# Cover Letter for KLF Proposal PR12-17-001 Submission to PAC45

## Response on TAC Physics Report

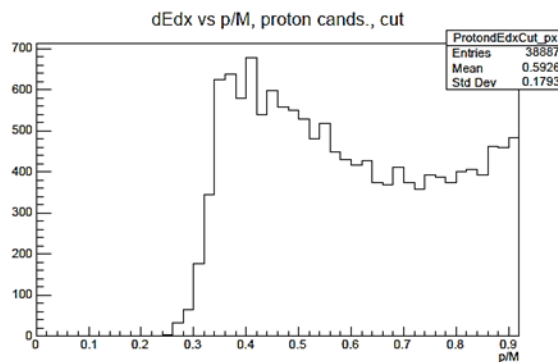
**Q1:** Since the initial momentum of the  $K_L$  is not known very well above 2 GeV/c from TOF (see the realistic 300 ps curve in Fig. **21**), it may be essential for high  $K_L$  momenta to detect all particles in the final state. The feasibility of inclusive measurements at higher  $K_L$  momenta will have to be determined on a case by case basis.

**A1:** Inclusive measurements make sense for the two-body final states only. There are four possible  $K_L p \rightarrow A+B$  two body reactions. All of them were carefully simulated within our proposal (see Appendix 5, Chapter 11). Three body final states need to be detected semi-exclusively or preferably exclusively to suppress possible backgrounds. For exclusively reconstructed events, the  $K_L$  momentum resolution is no longer a limiting factor, as shown on Fig. **22** (dashed green curve). Figures **32** and **46** further demonstrate this effect for dedicated reaction simulations.

The quoted start counter time resolution is 250 ps as shown in Fig. **23**.

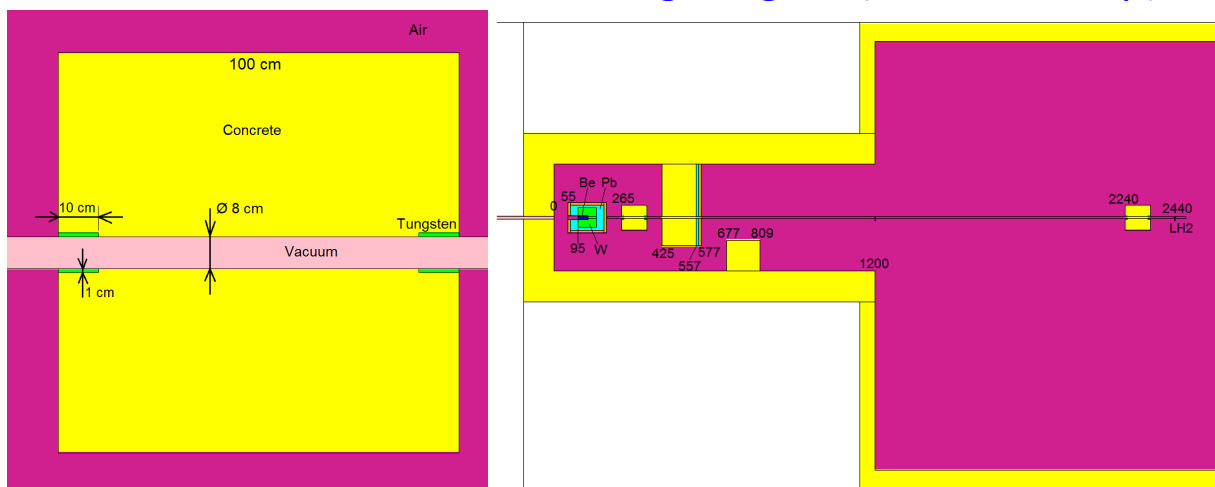
**Q1.** The contribution from the extended K<sub>L</sub> source to the time resolution may become significant for the lowest K<sub>L</sub> momenta. This should be included in any estimate of the overall time resolution and hence  $\Delta W$ . A combination of Be and Carbon as K<sub>L</sub> source may be favorable.

**A1:** All simulations performed for the K<sub>L</sub> proposal are done with an extended K<sub>L</sub> source. The time, momentum, and W resolution can be found in Figs. **21** & **22**. An increase of  $\Delta t$  seen on Fig. **21**(left) originates from the finite size of the K<sub>L</sub> source. However, such an increase in  $\Delta t$  does not lead to a noticeable increase in  $\Delta W$ , since  $t$  increases as well. Overall the W resolution is sufficient for all the proposed measurements over the full energy range.
